Southern California Edison Company

Subject: Docket No. 50-206
Updated Single Failure Analyses
San Onofre Nuclear Generating Station
Unit 1

The purpose of this letter is to transmit page changes to the reports entitled, "Engineered Safety Features Single Failure Analysis, San Onofre Nuclear Generating Station, Unit 1," and "San Onofre Nuclear Generating Station Unit 1, Reactor Protection System Single Failure Analysis" to reflect the reanalyses caused by several of the Cycle 10 modifications.

DCP# 3496.00TJ REV C SHT 12 OF 26

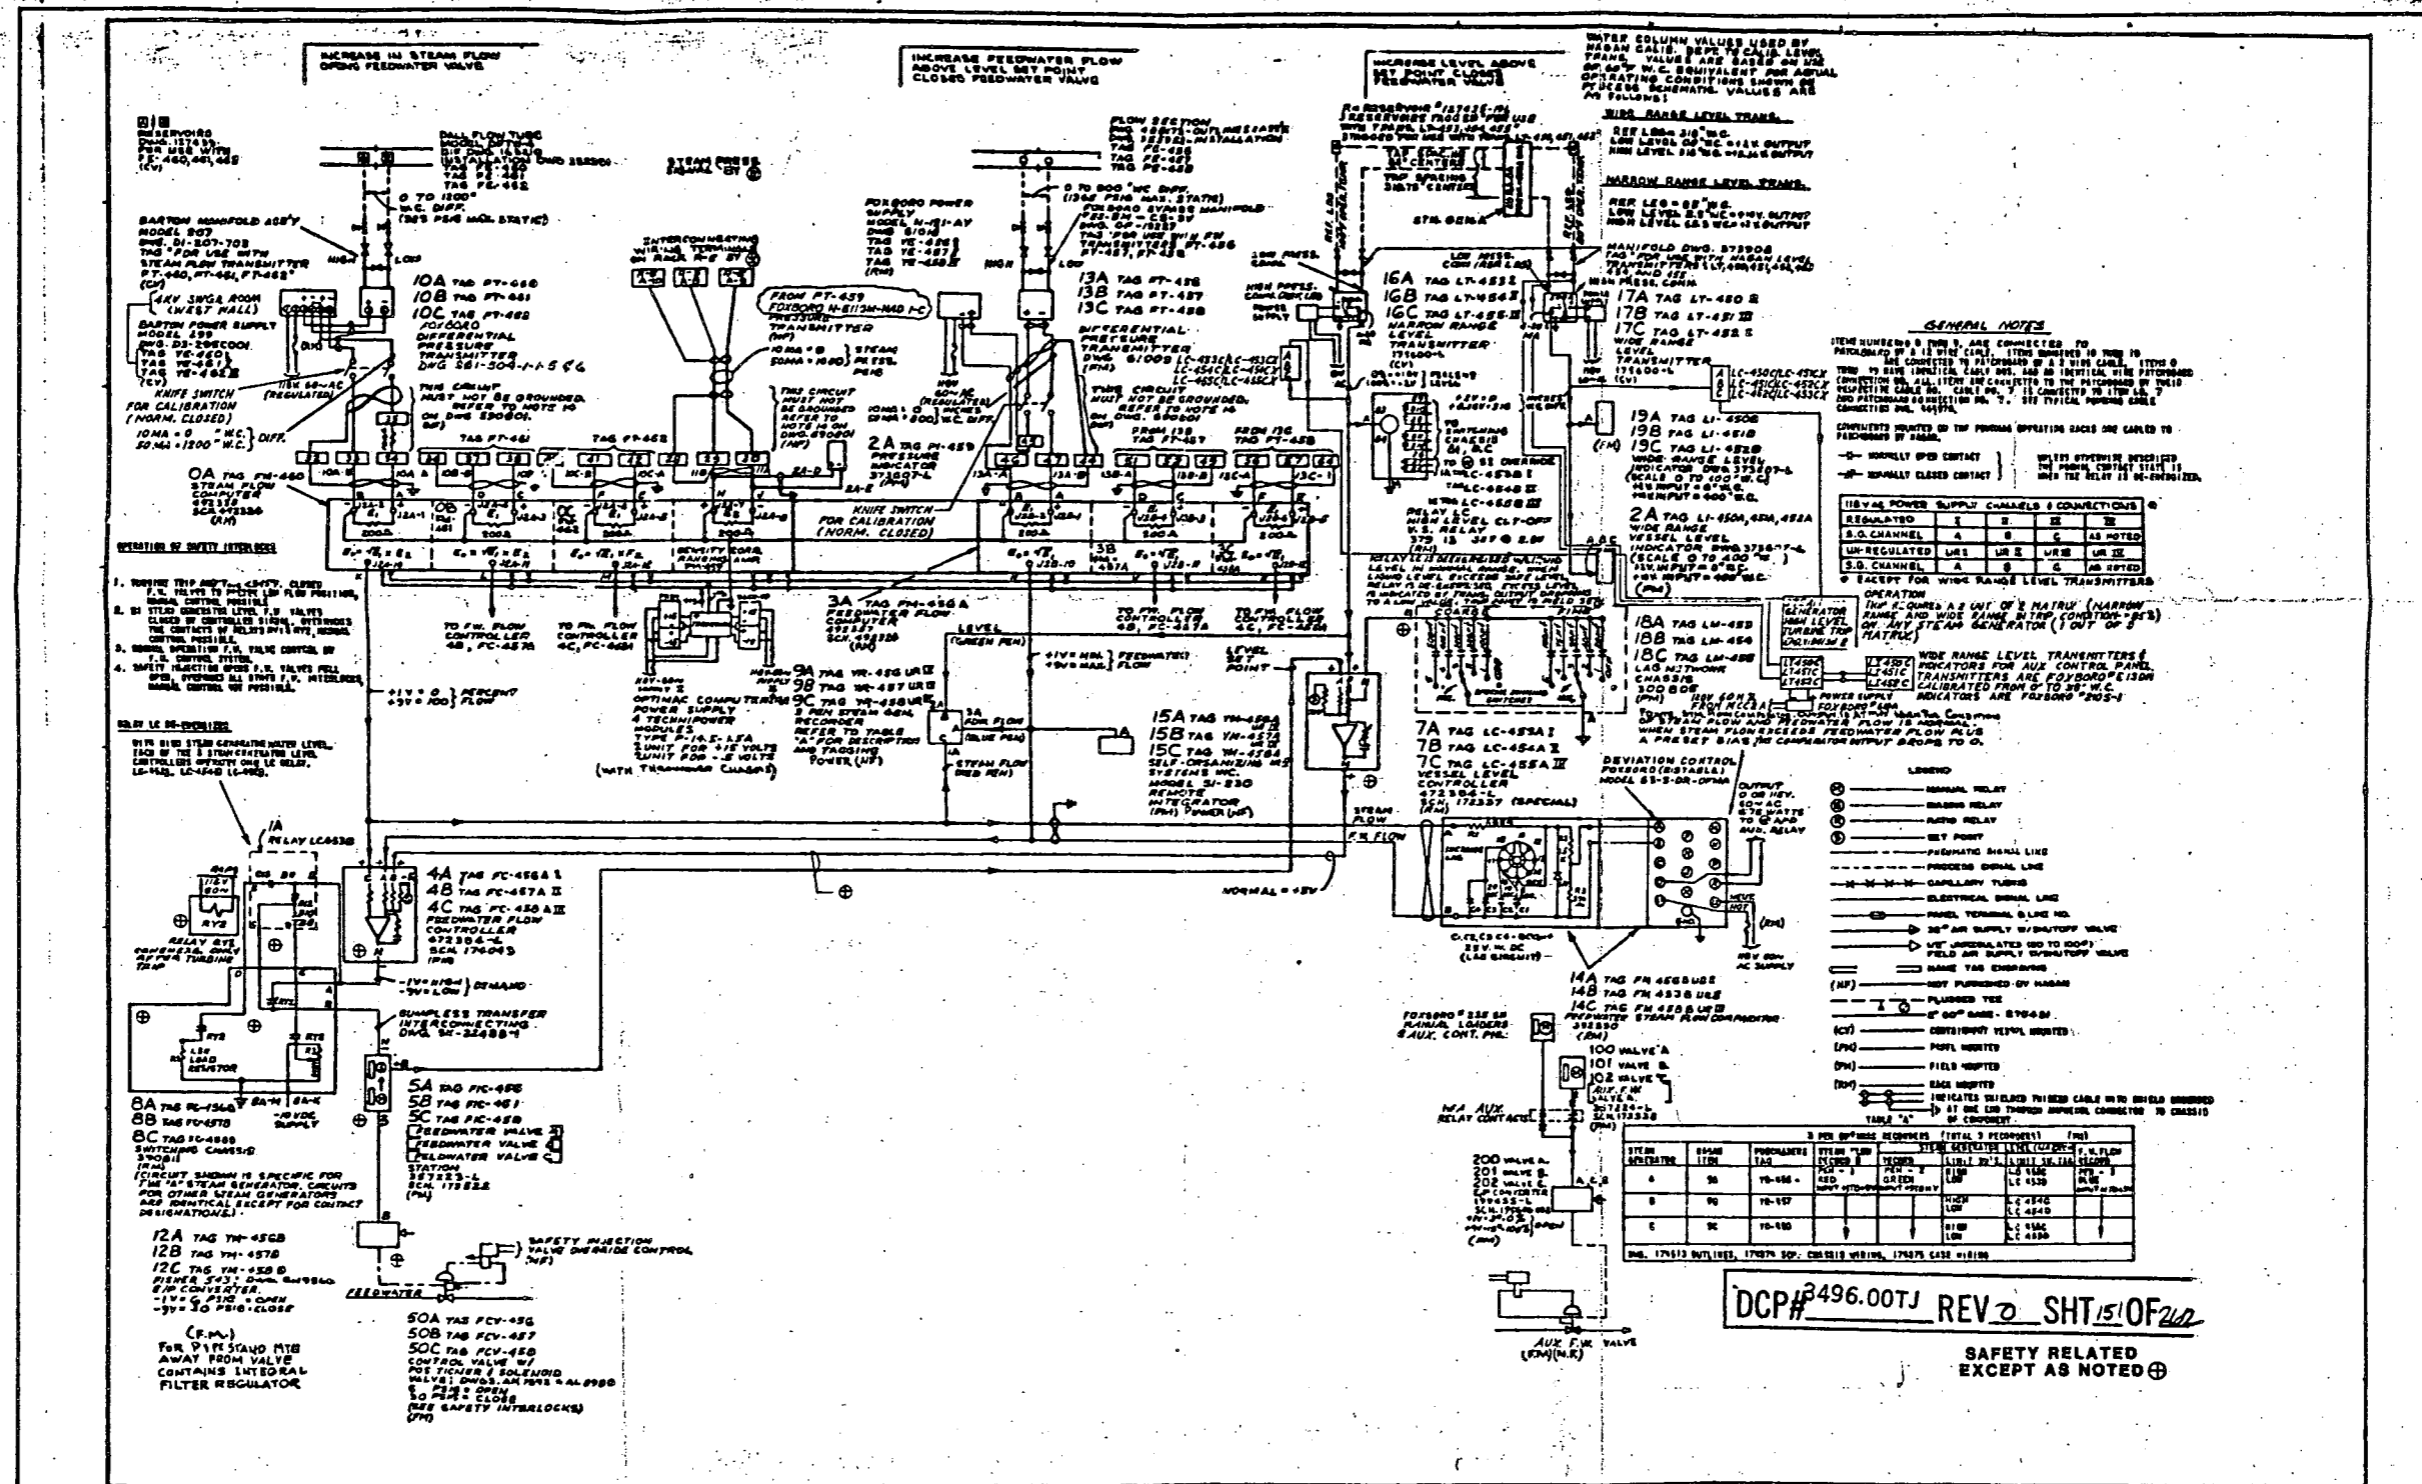
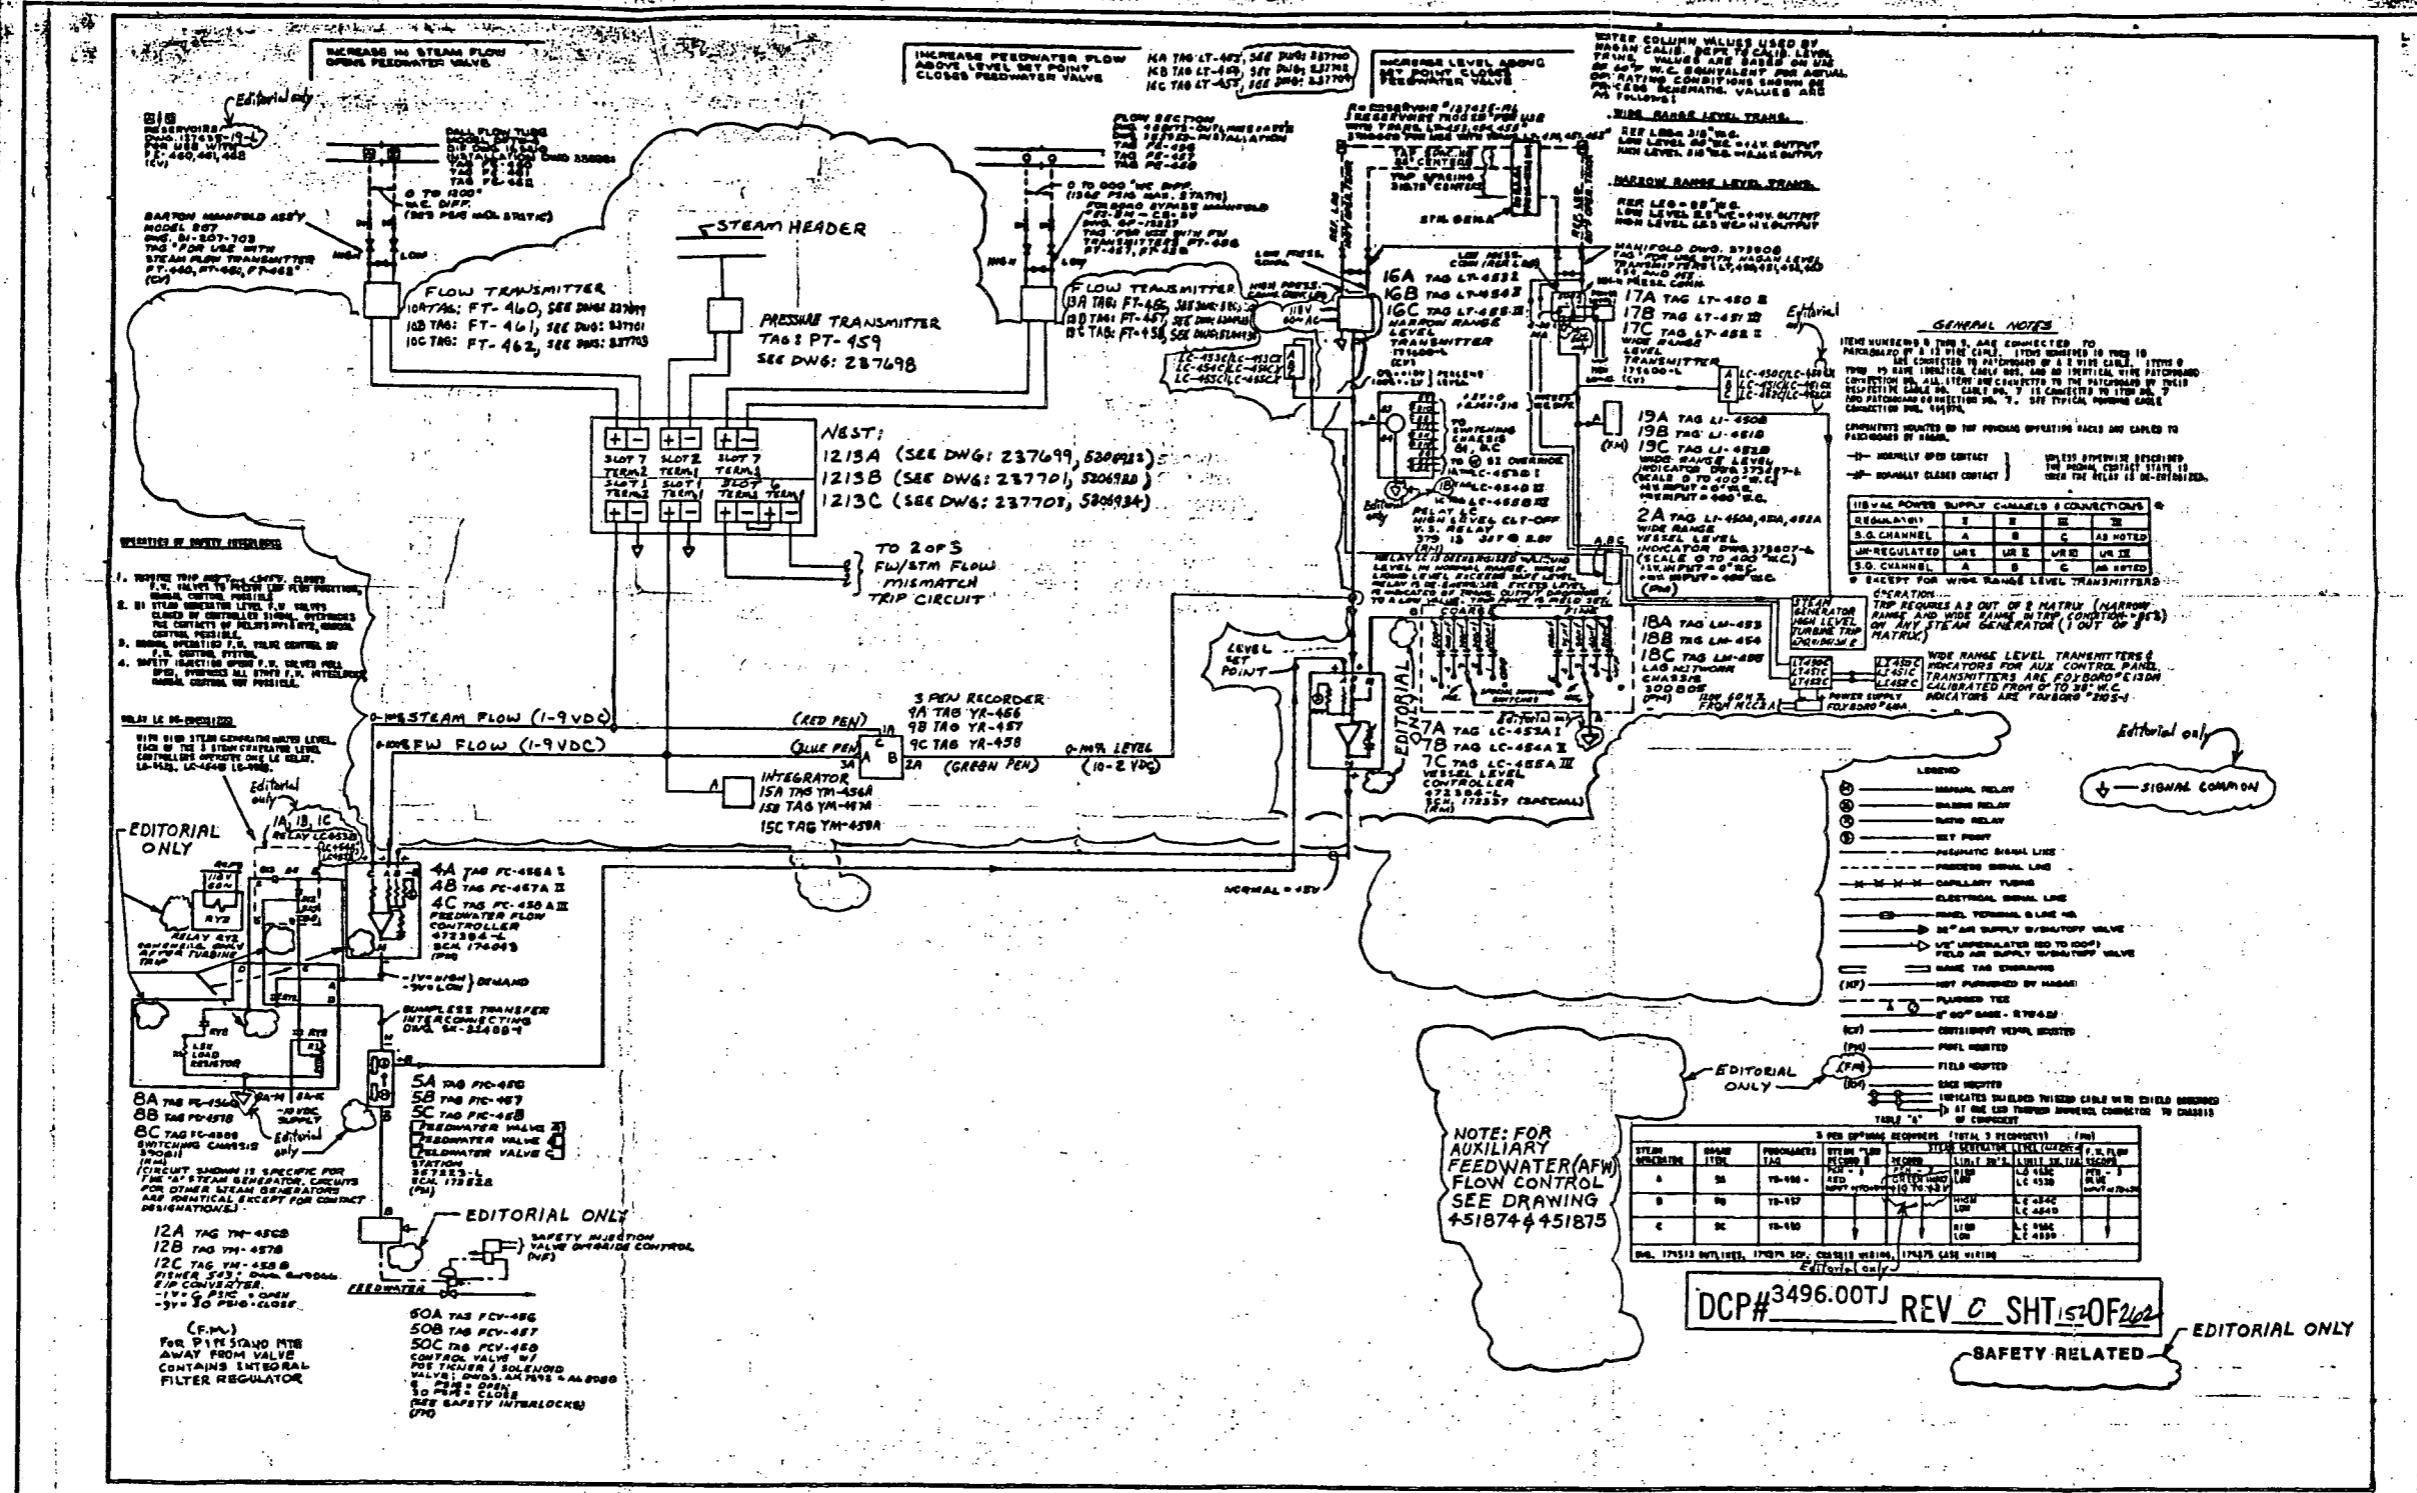
1. Originator <u>MARK MURPHY</u>		Tel: <u>975-3283</u>	Date <u>09/09/88</u>
Document Title <u>FEEDWATER CONTROL DIAGRAM</u>		DRAWM I.D. <u>IC-16</u>	QC <u>SR</u>
DESCRIPTION OF CHANGE <ul style="list-style-type: none"> - DELETE EXISTING FEEDWATER AND STEAM FLOW COMPUTERS AND COMPARATORS. - ADD REFERENCES TO LOOP DIAGRAMS, WHERE NEW COMPUTERS/COMPARATORS ARE SHOWN. - CHANGE DOCUMENT QC TO SR FROM SREAN. - NOTE THAT THIS DOCUMENT SUPERSEDES 1810-AC796-M0002, Hagan Dwg. 490436. 			
DCP#3496.00TJ REV 0 SHT 02 OF 02

DCP 1-9515.0BE REV 0 SHEET 52

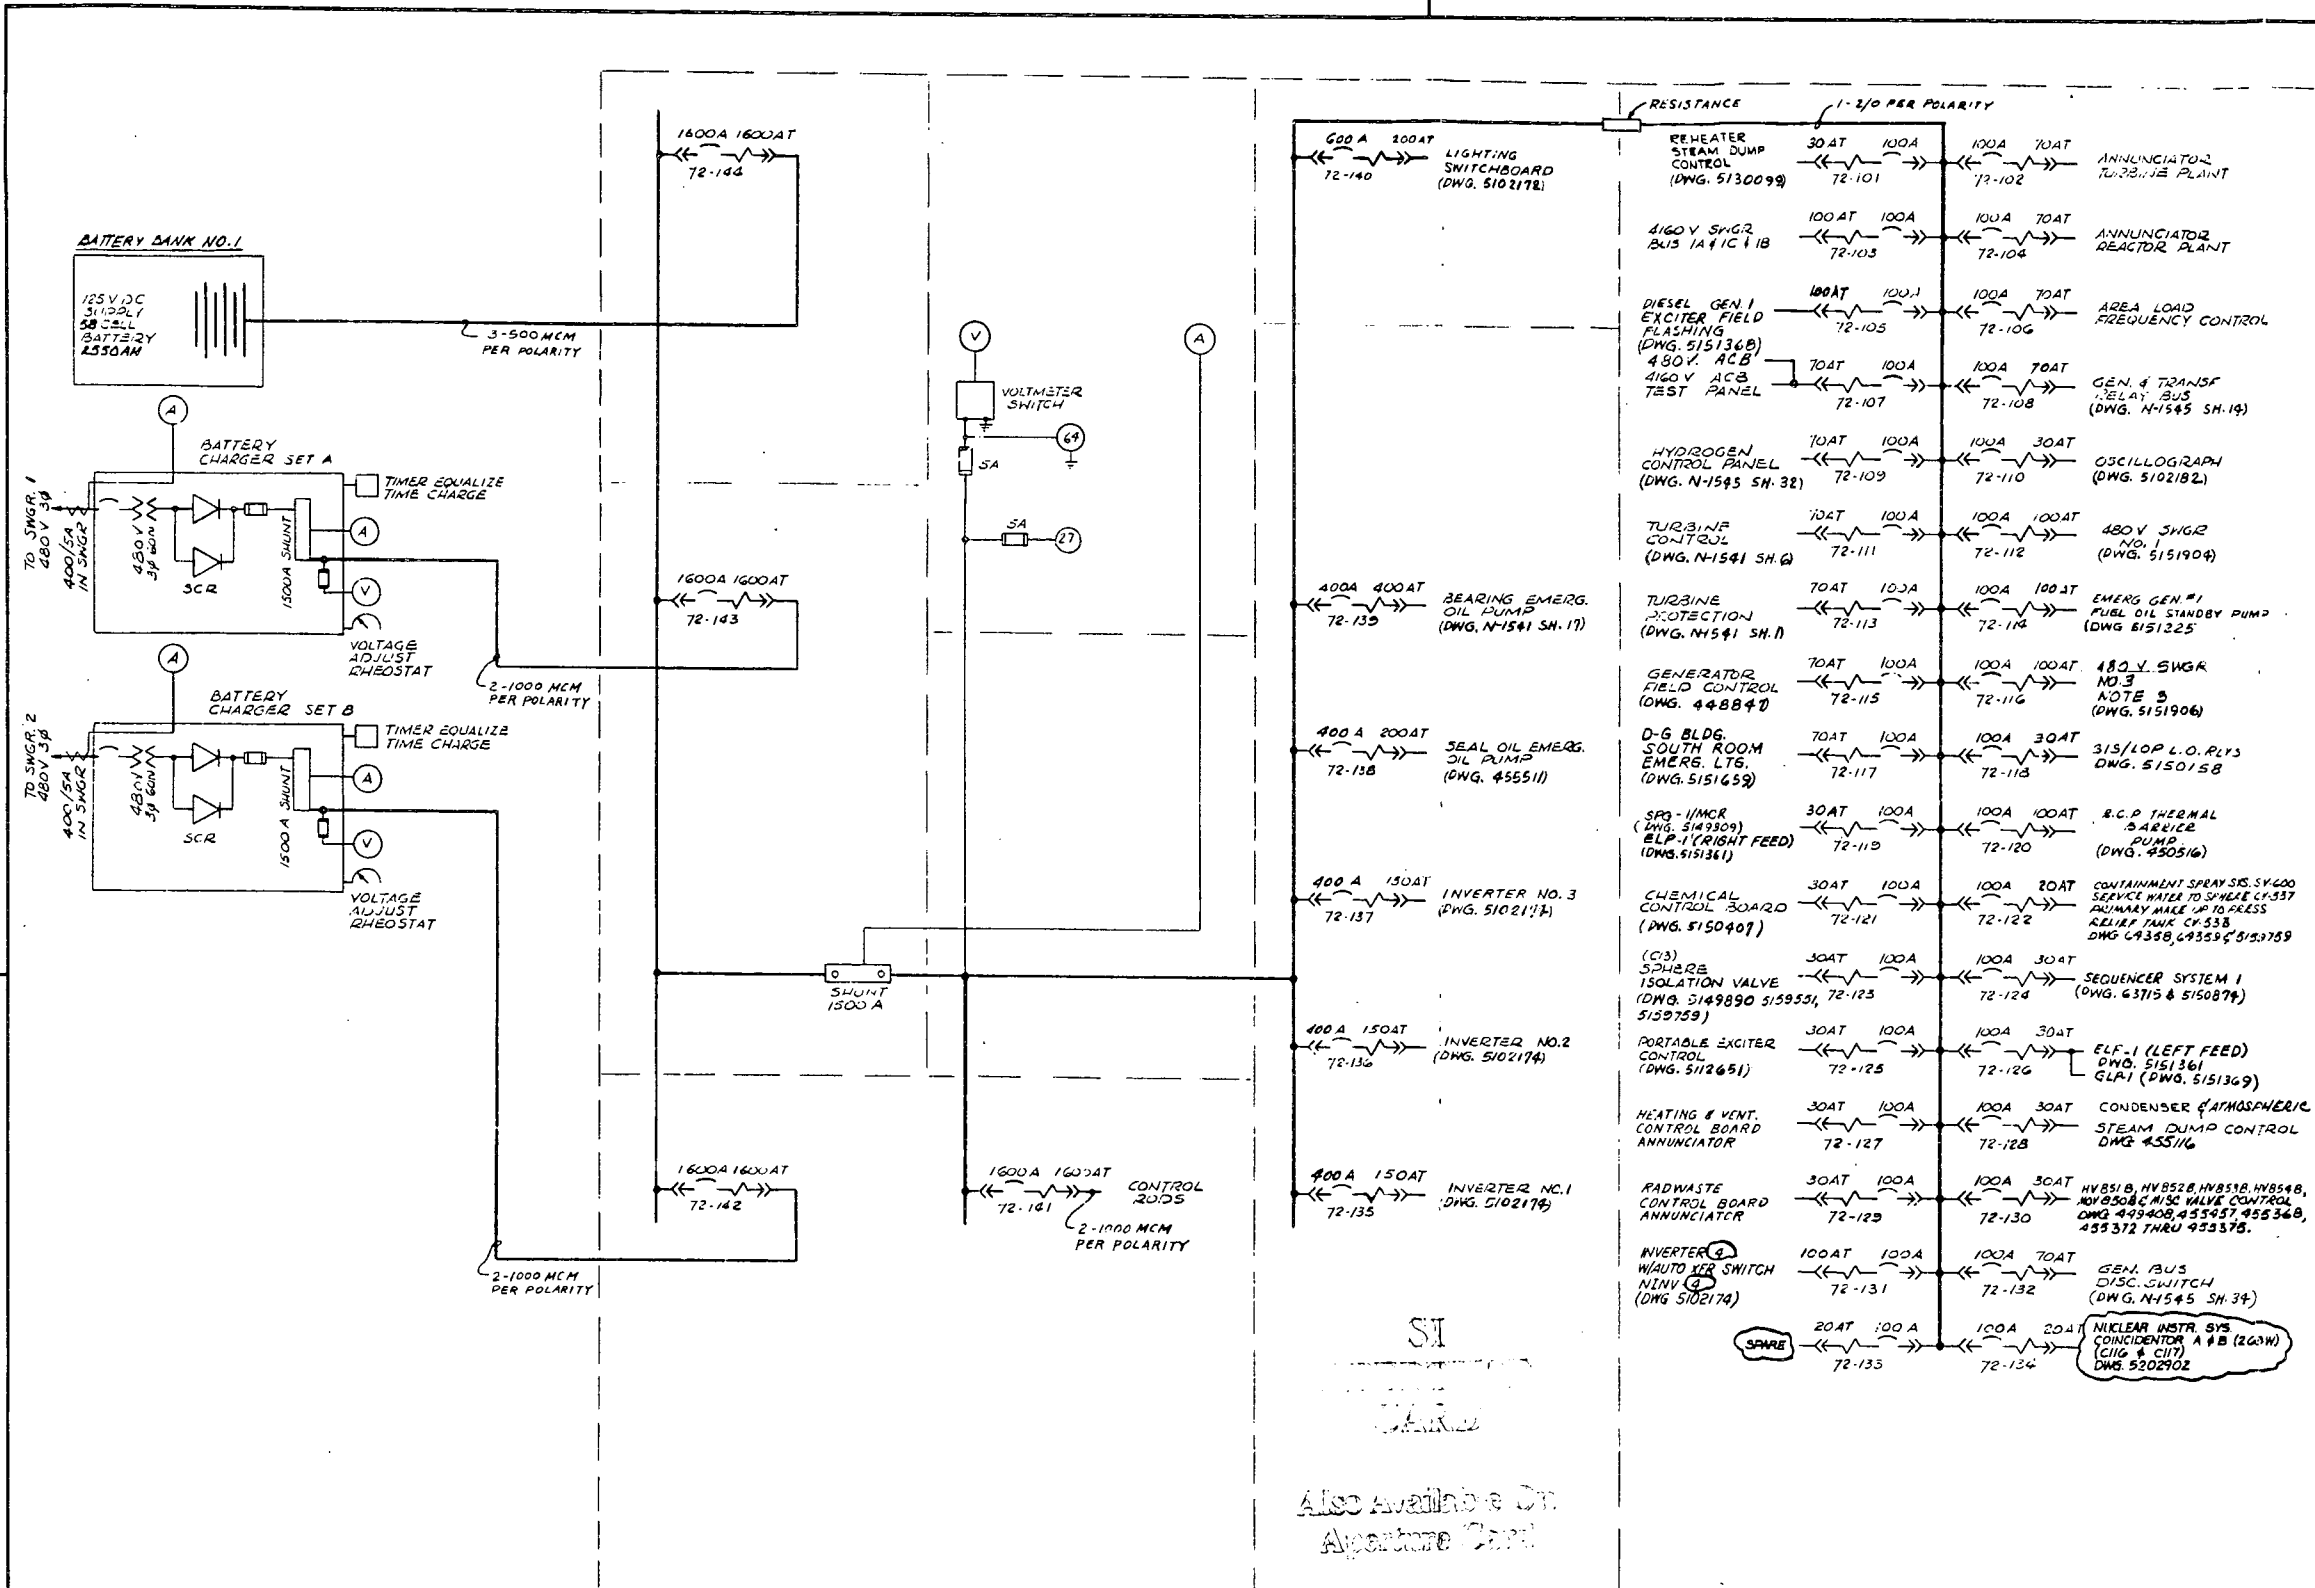
1. ORIGINATOR T. HONG (ELEG) DATE 9/14/88 ONE LINE DIAGRAM 125 VOLT DC SYSTEM 1 DESCRIPTION OF CHANGE <p style="text-align: center;">REVISE POWER SUPPLY TO BATTERY CHARGER D FROM SWGR 2 TO SWGR 1.</p>		PPN 807-5237 SHEET E-06 DATE SR	
Ref: Design Calculation/Specification Numbers N/A Seismic Category N/A
